Date:	June 1, 2012
To:	Sales Team, Customer Care Representatives & Product Data Group
From:	Marketing team
Re:	<b>PRIMO 1-PC/3-PC, VICHY 6043 ASY, NUEVO SERIES, AIKI, KAVA, HALO &amp; REVEAL RETURN PANEL, TRIPLE PLUS DOOR W/MIRROR, TILE REDI DRAIN DISCONTINUED, VIAGGI</b>

**COLLECTION – Primo 1-piece (200003) / Primo 3-piece (200003-S)**

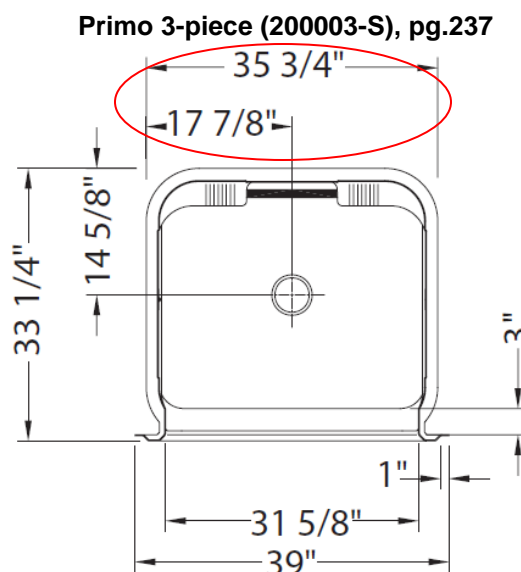
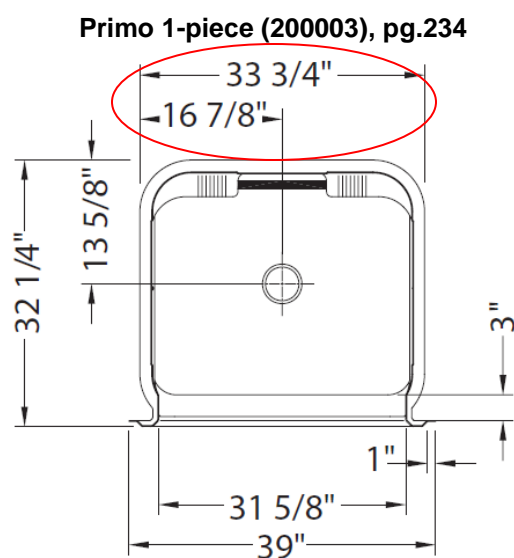
Take note that technical drawings for the bases of the Primo 1 pc (200003) & Primo 3 pc (200003-S) in the Collection price book pages 234 & 237 do not read as they should. Please see below for correct technical drawings. The technical drawings on the MAAX website have been updated.
